## UNITED STATES ENVIRONMENTAL PROTECTION AGENCY

## Memorandum

Subject: Field Inspection Former Plainwell Impoundment, Dec. 3, 2012

Photo 2, Approximate location: West end of RA 4A. Severely eroded bank. (Mendoza, 12/3/12)

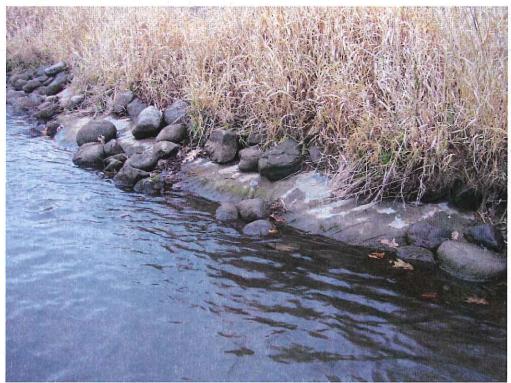
2. Approximate Location: West end (north) of RA 4A to start of RA 5. Lat 42.45406 Long - 85.65257. The area shows signs of erosion (See Photo 2 Enclosure). Continued erosion in this area has the potential to expose contaminated residuals.

Requested Repair: Extend the current downstream boundary of repairs in RA 4A to the bend up to the border of Removal Area 5A, using the same conceptual design in the November 15, 2012 Bank Repair Plan.

Photo 3, Approximate location, Removal Area 3A. Exposed geotextile (Mendoza, 12/3/2012)

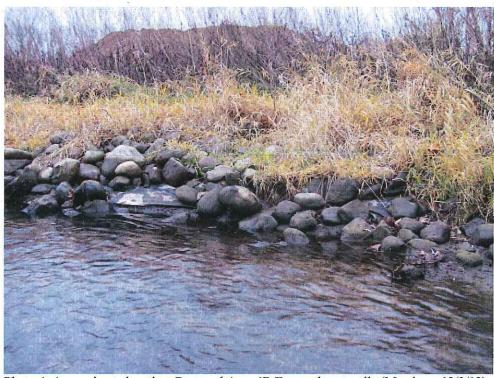
- 3. EPA and MDEQ observed the following areas where the rock armoring has fallen off the bank exposing the geotextile fabric beneath. We request that these areas be repaired by replacing the rock to avoid bank failure:
  - a) Approximate Location: Removal Area 3A, Lat 42.45127 Long -85.65054 (see Photo 3 Enclosure)
  - b) Approximate Location: Removal Area 4B, Lat 42.45181 Long -85.65208 about 20 feet upstream of the open area where we off loaded our boats (See Photo 4, Enclosure)
  - c) Approximate Location: Removal Area 9A, Lat 42.45505 Long -85.66090
  - d) Approximate Location: Removal Area 9A approximately 200 feet upstream of: Lat 42.45505 Long -85.66090.
  - e) Approximate Location: Western Channel Area, upstream of planned repair area. Lat 42.5521 Long -85.66835. (See Photo 5, Enclosure.)
